ADDENDUM NO. 5

DATE: March 18, 2020

PROJECT: Hammond High School Renovation and Addition
Columbia, Maryland
Architect Project No. 18011

1 PARTIAL FLOOR PLAN - ELECTRICAL - AUDITORIUM CATWALK
E7.00 SCALE: 3/32" = 1'-0"

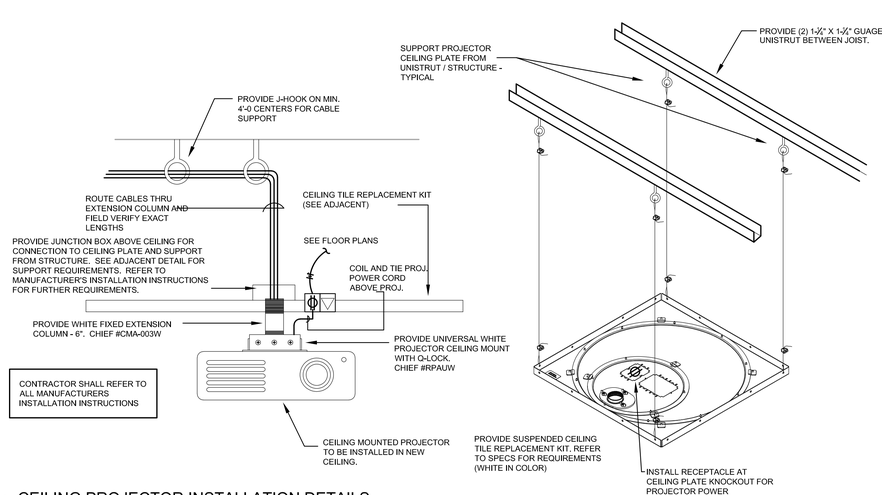
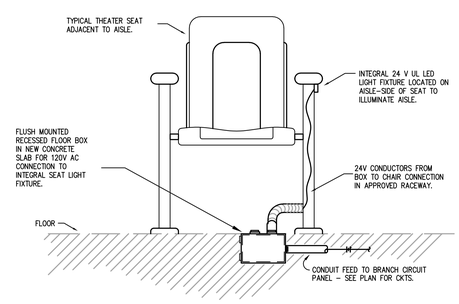
- Sheet E7.00 – Details – Electrical
  - **REPLACE SHEET** – Lighting Fixture changes and Catwalk view added, refer to revision clouds for details.
- Sheet E7.05 – Details – Electrical

1 FIRST FLOOR PLAN - FIRE ALARM ANNUNCIATOR ZONE 1
EF1.1 SCALE: 3/64" = 1'-0"

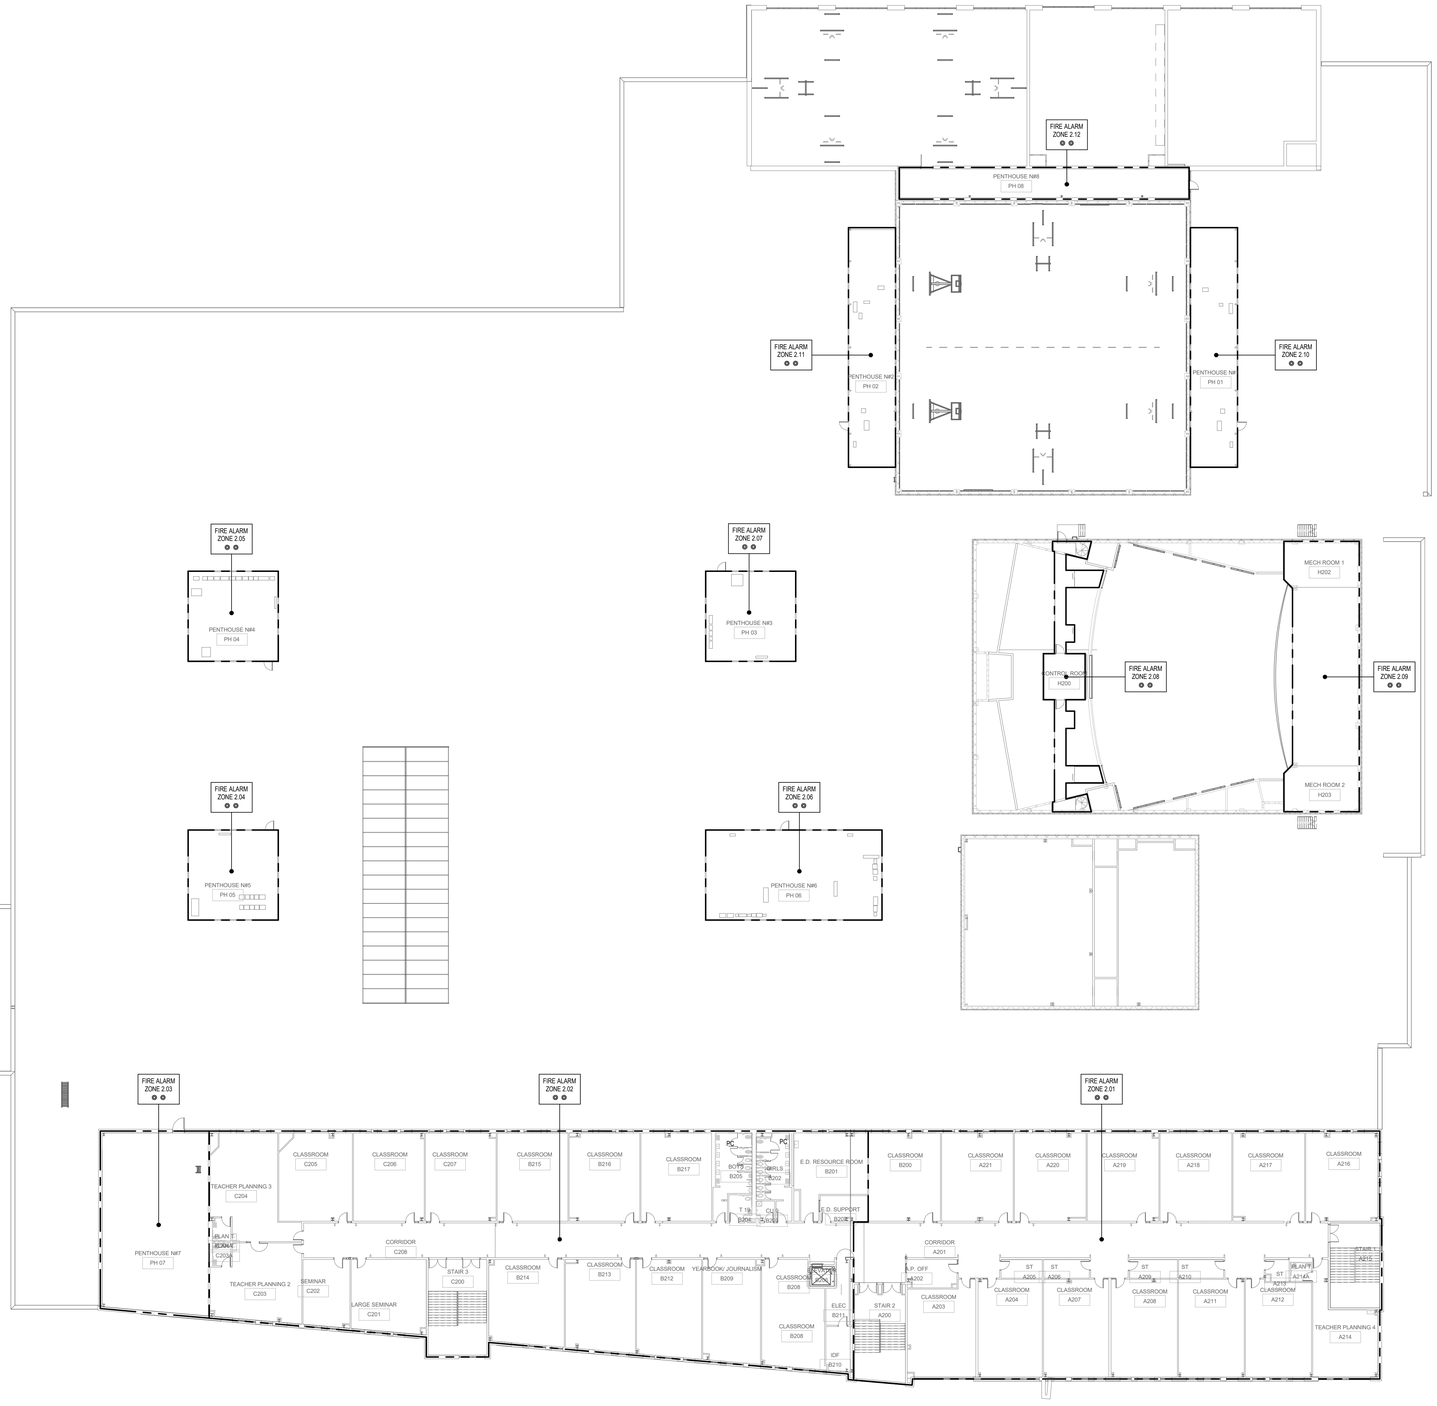
- ❑ **ADD SHEETS** – EF1.1 and EF2.1 – Fire Alarm Annunciator
